CITY PLANNING COMMISSION

APPLICANT	Francis Koo & Assoc. - 555 University Avenue, Ste.130,Sacramento 95825		
OWNER	Edwin, Maylene, Alfred & Marjorie Dong - 6180 Colgate Ct.,Sacto. 95831		
PLANS BY	Francis Koo & Assoc. - 555 University Avenue, Ste.130,Sacramento 95825		
FILING DATE	5-2-84	ENVIR. DET.	REPORT BY SD:sg
ASSESSOR'S-PCL. NO.	117-152-06

PROPOSAL: The applicant is requesting the necessary entitlements to subdivide 5+ vacant acres into 23 single family lots known as Carlin Estates II.

**CARLIN ESTATES II
TENTATIVE SUBDIVISION MAP**

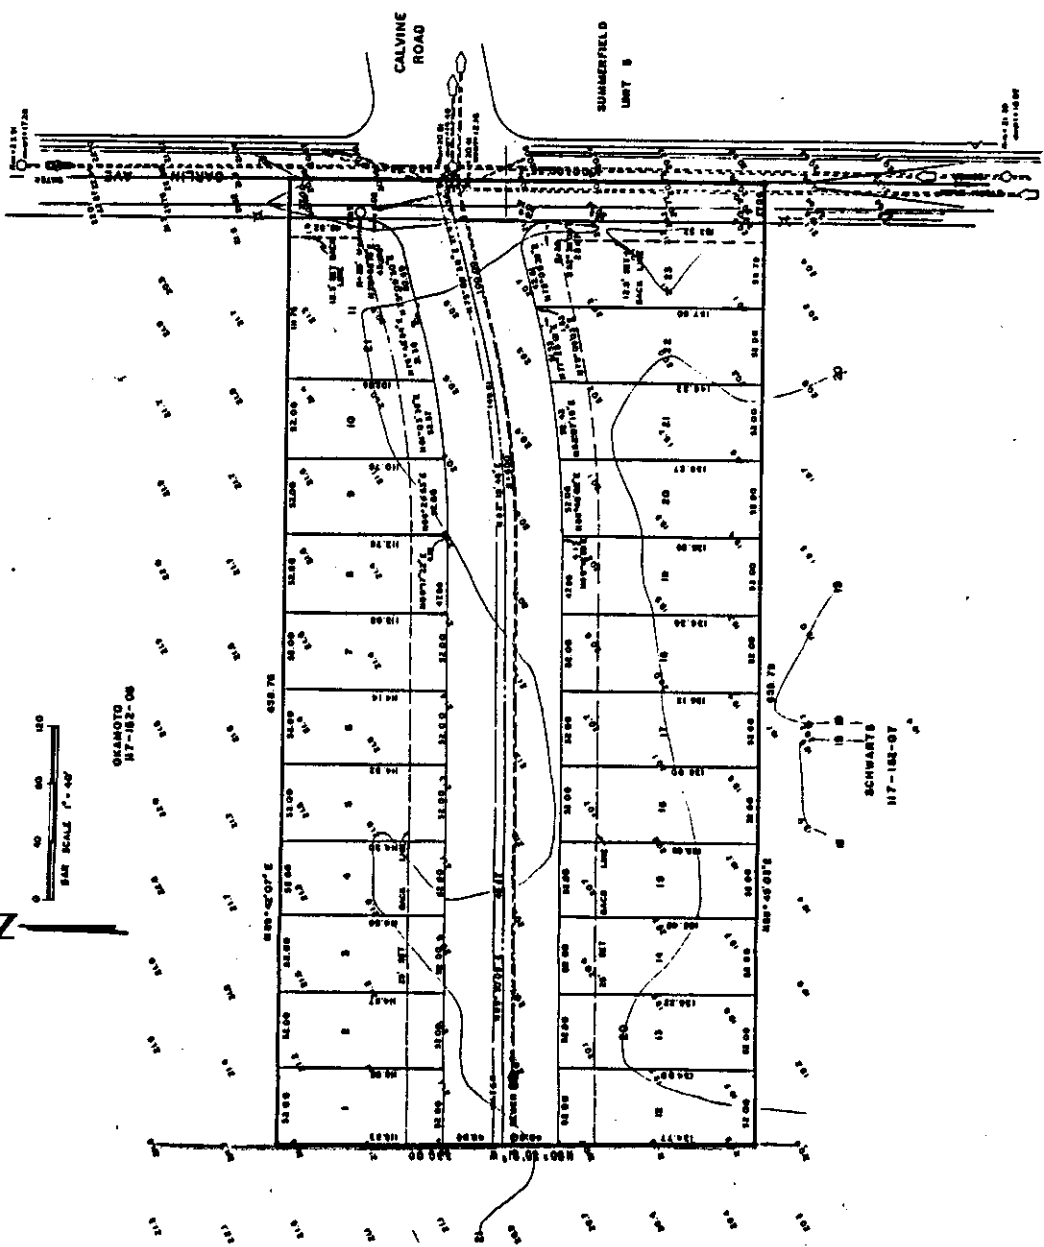
The applicant proposes to subdivide the 5+ acres into 23 single family lots. The interior lots comply with the minimum required lot width of 52 feet. In the past, staff has requested wider lots on major streets so that turnaround driveways can be provided. A major street is 90 feet in width. Calvine Road, at 80 feet in width, does not qualify as a major street. In addition, the Traffic Engineer indicates that the ultimate traffic volume on Calvine Road will not necessitate the restriction of backout driveways.

One corner lot is 57 feet wide. The minimum corner lot width is 62 feet. Duplexes are allowed by right on corner lots in the R-1 zone. The applicant has indicated a willingness to restrict development of lot 23 to a single family unit. Staff, therefore, supports the requested variance/subdivision modification.

The South Sacramento Community plan contains a policy that lots fronting on roads such as Calvine Road have a 35 foot front setback. The map is conditioned to make note of this requirement.

17. Lot 23 shall be restricted to single family development. A note shall be placed on the final map referencing this condition.
